SHEET NUMBER	SHEET NAME
GENERAL	
G000	COVERSHEET
G001	ENERGY CODE, LEAKAGE TESTING, & VENT CALCS
SURVEY	
S-1	TOPOGRAPHIC & BOUNDARY SURVEY
S-2	TOPOGRAPHIC & BOUNDARY SURVEY
ARCHITECTURAL DEMOLITION	
AD101	DEMOLITION SITE PLAN
AD102	DEMOLITION LOT COVERAGE SITE PLAN
CIVIL	
C100	TESC PLAN
C110	TESC DETAILS + NOTES
C200	TREE PLAN
C210	TREE DETAILS + NOTES
C300	CIVIL SITE PLAN
C310	CIVIL DETAILS + NOTES
C311	CIVIL DETAILS
SHORING	
AS101	ARCH. SHORING AND EXCAVATION SITE PLAN
AS111	EXCAVATION SITE SECTIONS
SH1.1	GENERAL SHORING NOTES
SH2.1	SHORING PLAN
SH3.1	SHORING DETAILS
SH4.1	SHORING ELEVATIONS
SH4.2	SHORING ELEVATIONS
ARCHITECTURAL	
A101	PROPOSED SITE PLAN
A102	SETBACK SITE PLAN
A103	PROPOSED LOT COVERAGE SITE PLAN
A104	SHORELINE REST. & TREE RETENT. / REPL. PLAN
A105	ENLARGED SHORELINE PLANTING PLAN
A211	LOWER FLOOR PLAN
A212	MAIN FLOOR PLAN
A213	ROOF PLAN
A301	EXTERIOR ELEVATIONS (N&E)
A302	EXTERIOR ELEVATIONS (S&W)
A401	BUILDING SECTIONS

SCOPE OF CHANGES:
• ROOF STORMWATER DRAINAGE CHANGE FROM SHEET DRAINAGE & HARDPIPED TRENCH SYSTEM TO GUTTER/DOWNSPOUT TIGHTLINED DRAINAGE SYSTEM. OVERALL UNDERGROUND HARDPIPED DRAINAGE SYSTEM REMAINS.
• ADDITION OF TRASH ENCLOSURE
• NEW WATER M

1 ROOF PLAN
1/4" = 1'-0"

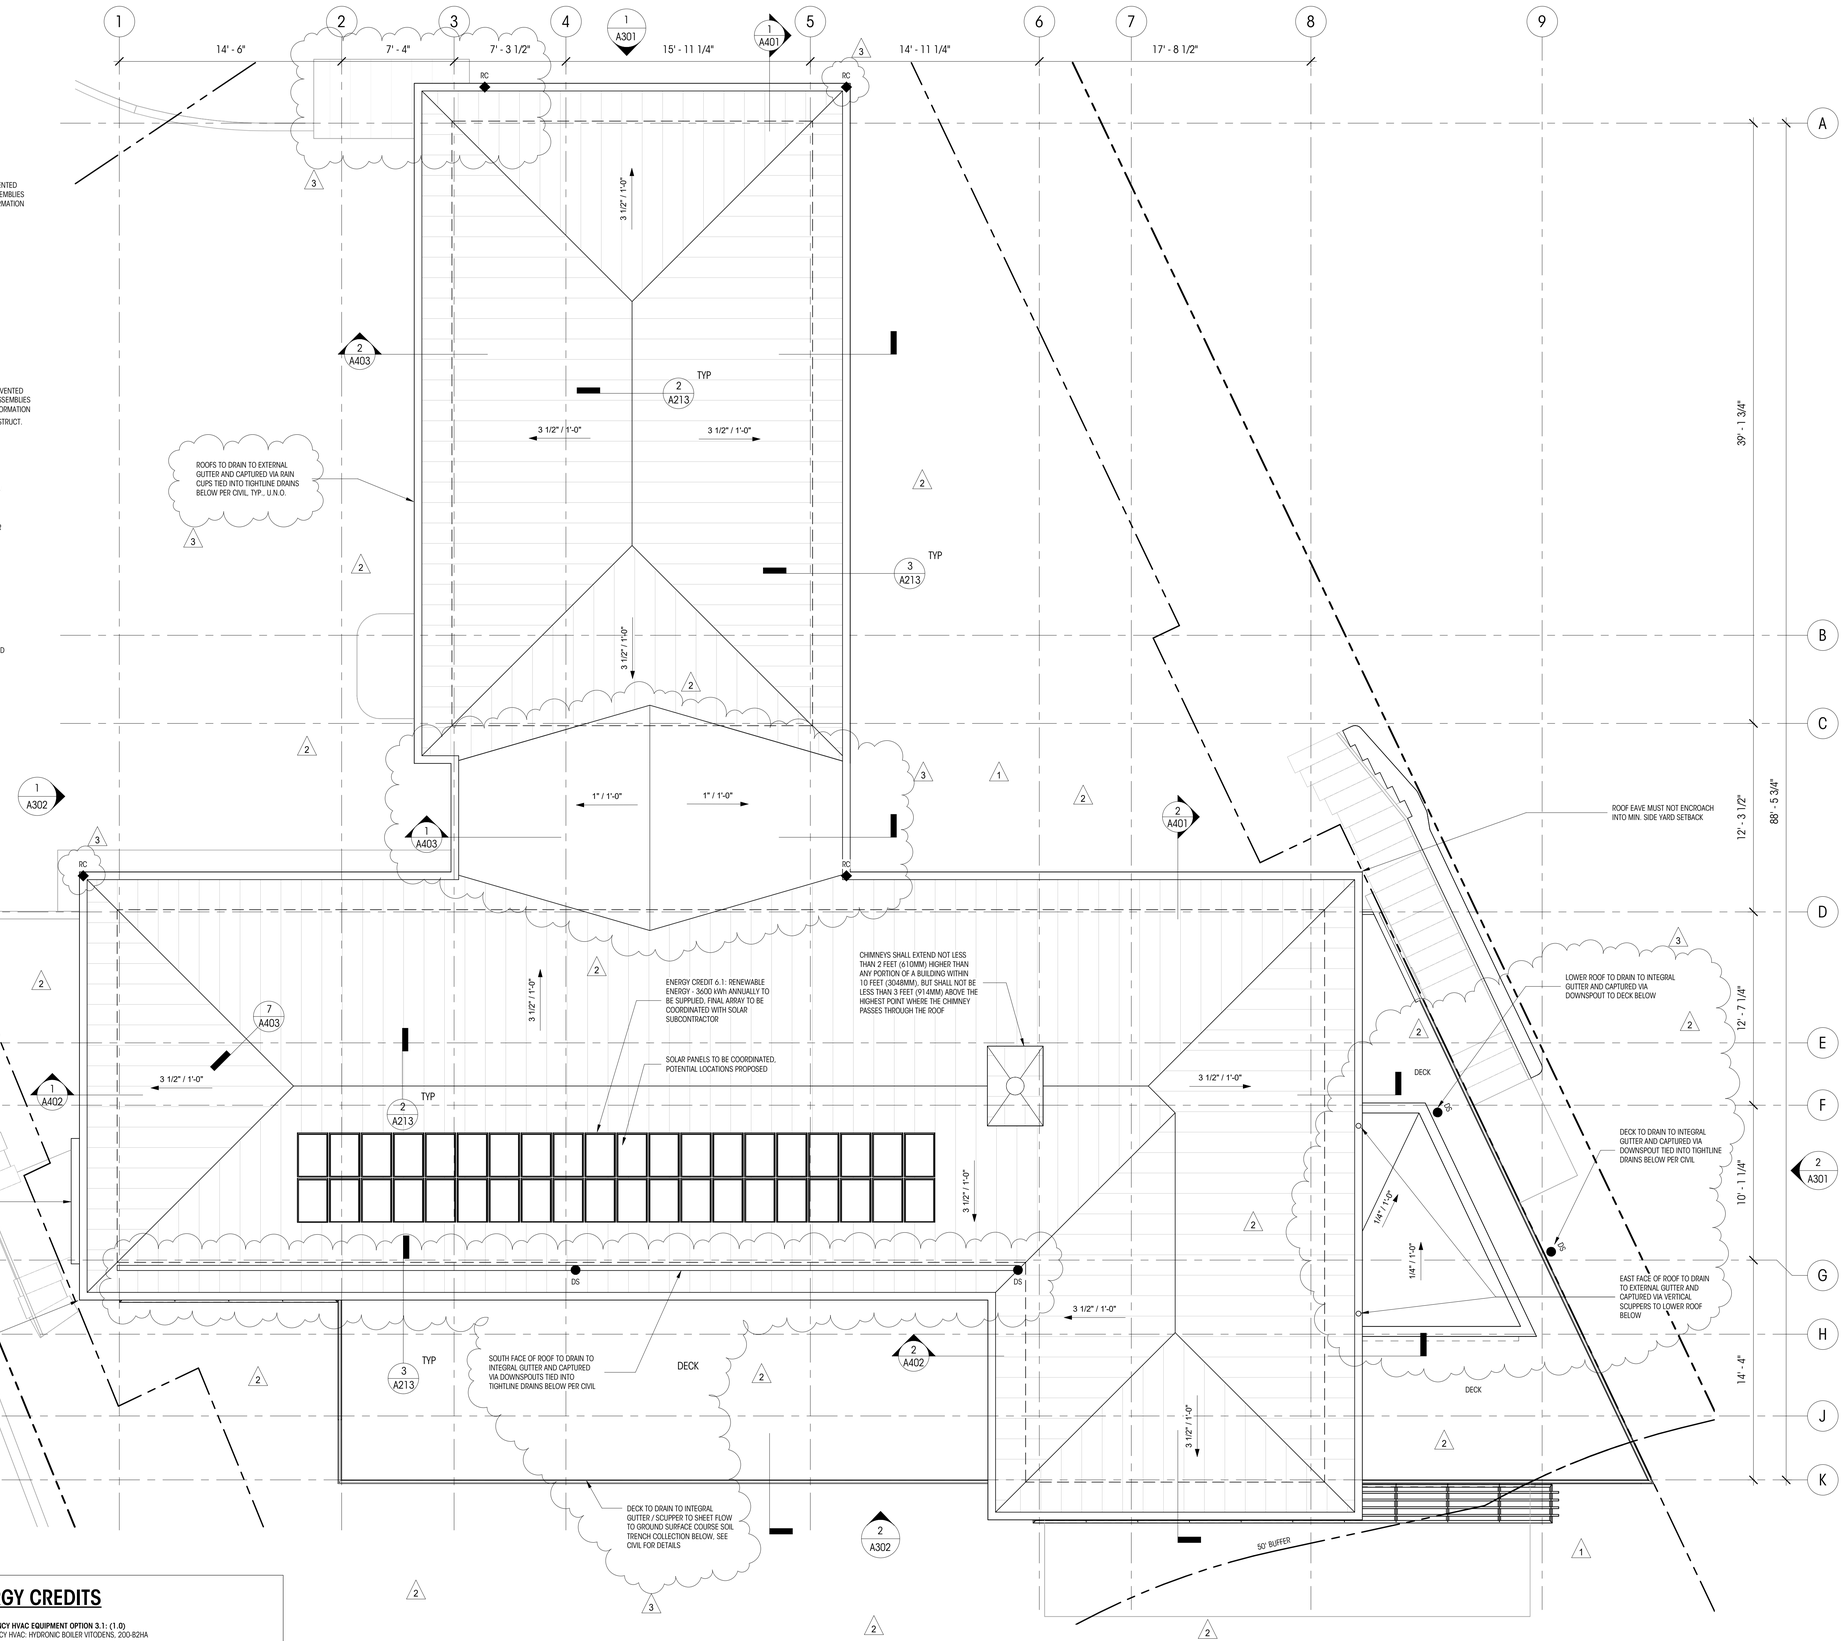
SCOPE OF CHANGES:
- ROOF DOWNSPOUTS SHOWN
- ADDITION OF TRASH ENCLOSURE SHOWN
- LOT COVERAGE TRANSFER; INCREASE OF PLANTER AT SOUTH SIDE OF DRIVEWAY TO ACCOUNT FOR TRASH ENCLOSURE COVERAGE.
- CHANGE TO ENERGY CREDITS
- NO CHANGE OF GFA, HARDSCAPE, FOOTPRINT OR EXTENT OF ROOF OVERHANG.
